MILITARY SPECIFICATION SHEET

SWITCH, PUSH BUTTON, ILLUMINATED, 4-LAMP, SOLID MOUNT,
RFI SHIELDED, MOISTURE SEALED, HIGH IMPACT SHOCK RESISTANT

This amendment forms a part of MIL-S-22885/80E, dated 24 February 1984, and is approved for use by all Departments and Agencies of the Department of Defense

FIGURE 3. Plug-in switch / indicator assembly

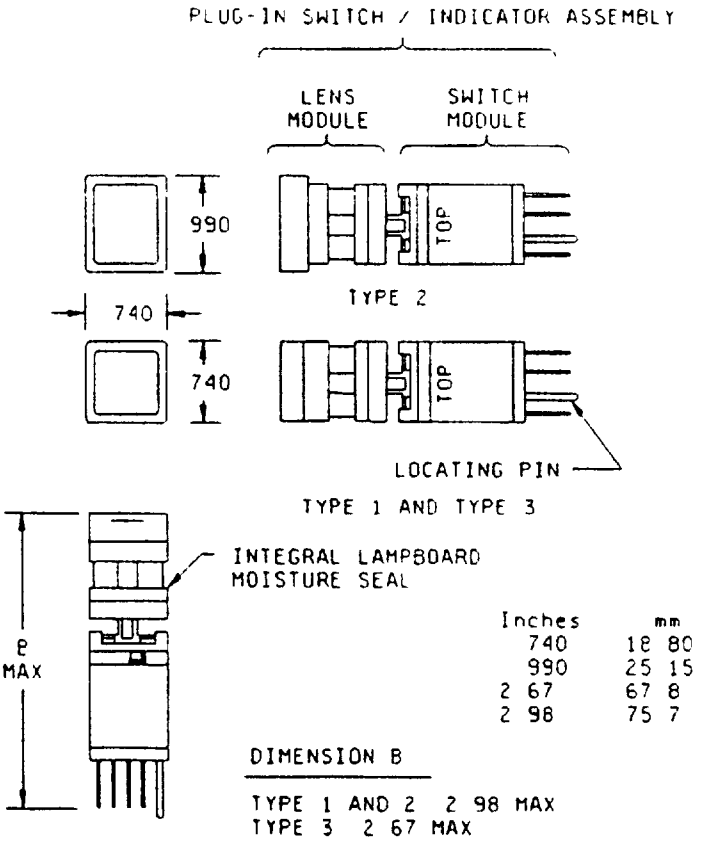
* Figure 3, delete and substitute
